The Extension of NY3P SOP8 Transfer Board

Description: Extend NY3P SOP8 Transfer Board to support NY9TP16AS8 package.

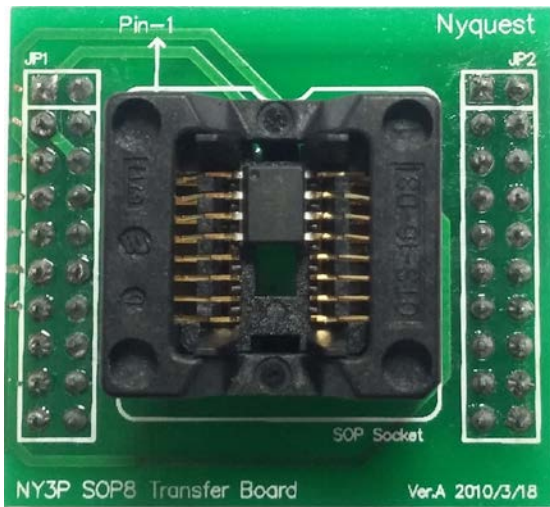
Reason: In order to support NY9TP16AS8 package, NY3P SOP8 Transfer Board has to be modified for accommodating programming demands.

Solution: Please follow the steps below to modify:

Use NY3P SOP8 Transfer Board (Ver.A) 2010/3/18 as the picture below:

Flip over the board and short-circuit SOP Socket Pin-1 and Pin-4 as the picture below:
